RE: Agreement No. 1774
Project Number T201769002
Traffic Impact Study Services
Task 4A-Fort DuPont Redevelopment

Johnson, Mirmiran and Thompson (JMT) has completed the review of the Traffic Impact Study (TIS) for the Fort DuPont Redevelopment, prepared by Duffield Associates, Inc. This task was assigned Task Number 4A. Duffield Associates, Inc. prepared the report in a manner generally consistent with DelDOT's *Development Coordination Manual*.

FORT DUPONT REDEVELOPMENT
TRAFFIC IMPACT STUDY
DELAWARE CITY, NEW CASTLE COUNTY, DELAWARE

FIGURE 1

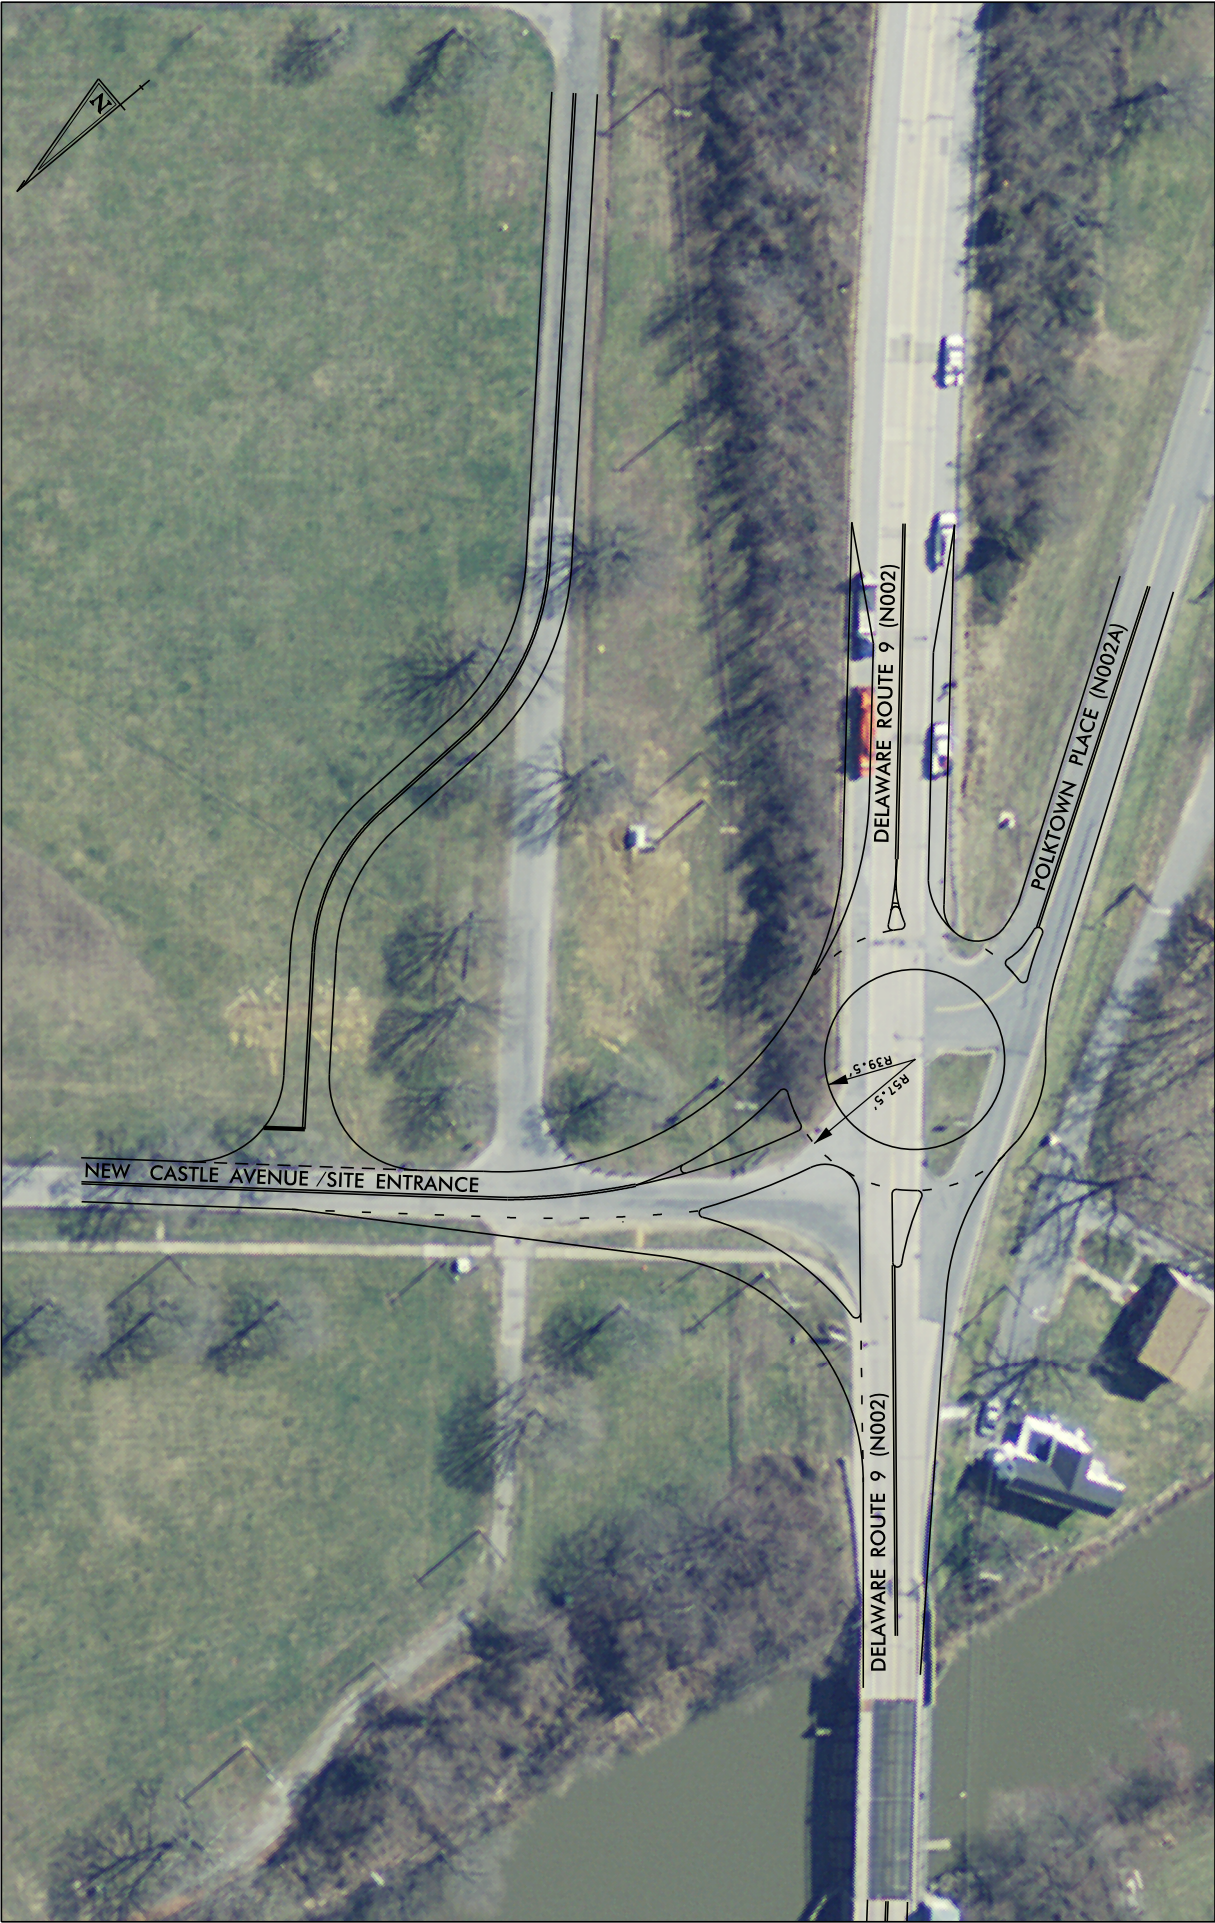
Attached Figure 1 depicts a conceptual layout of the single-lane roundabout. This layout includes the provision of a westbound yield-controlled channelized right turn lane to accommodate the projected high number of right turning vehicles along the westbound New Castle Avenue approach (volumes of 212, 355, and 395 are projected during the Case 5 weekday AM, weekday PM, and Saturday peak hours, respectively.) However, without the channelized right turn lane the roundabout would continue to operate at acceptable levels of service. As such, it is recommended that the final design of the roundabout be determined during the Entrance Plan review process. Other possible improvements that were also considered but not recommended are described in more detail within the supporting documentation which begins on Page 9.

It is acknowledged that installing a roundabout at this location would involve significant geometric improvements due to the large grade differentials between Polktown Place, Delaware Route 9 and New Castle Avenue, and would also impact the earthwork embankments and approaches for two adjacent bridges in the area. As such, it is recommended that the developer coordinate with DelDOT's Development Coordination Section to ensure the feasibility of constructing a roundabout and share the roundabout design with the appropriate DelDOT sections.

Furthermore, per the Federal Highway Administration (FHWA) publication *Roundabouts: An Information Guide*, speed limits within roundabouts are typically less than 30 miles per hour. The speed limits to the north and south of this intersection is 35 and 50 miles per hour, respectively. Therefore, it is recommended that speed limits along the Delaware Route 9 approaches to the roundabout be reduced. Reduced Speed Limit Ahead (W3-5) signs should also be provided along

1. Prior to the issuance of the 50th residential building permit of the Fort DuPont Redevelopment, the developer should modify the New Castle Avenue/Site Entrance A and Polktown Place intersections with Delaware Route 9 to be a single-lane roundabout consistent with the proposed lane configurations as shown on Page 9 and in the table below:

The roundabout design should follow *NCHRP: Report 672 2nd Edition – Roundabouts: An Information Guide*, DelDOT’s *Road Design Manual*, and DelDOT’s *Design Guidance Memorandum Number 1-26* for roundabouts. The roundabout should include the design to realign the internal roadway east of the roundabout that provides connectivity between New Castle Avenue and Wilmington Avenue. The roundabout should also be designed to accommodate pedestrians and bicyclists and be in compliance with the *Delaware Byways Program*. Additionally, lighting at the roundabout should be evaluated per DelDOT’s lighting guidelines. The developer should submit a plan to DelDOT’s Development Coordination and other pertinent sections depicting the roundabout design. The final design of the roundabout should be determined during the Entrance Plan review process.
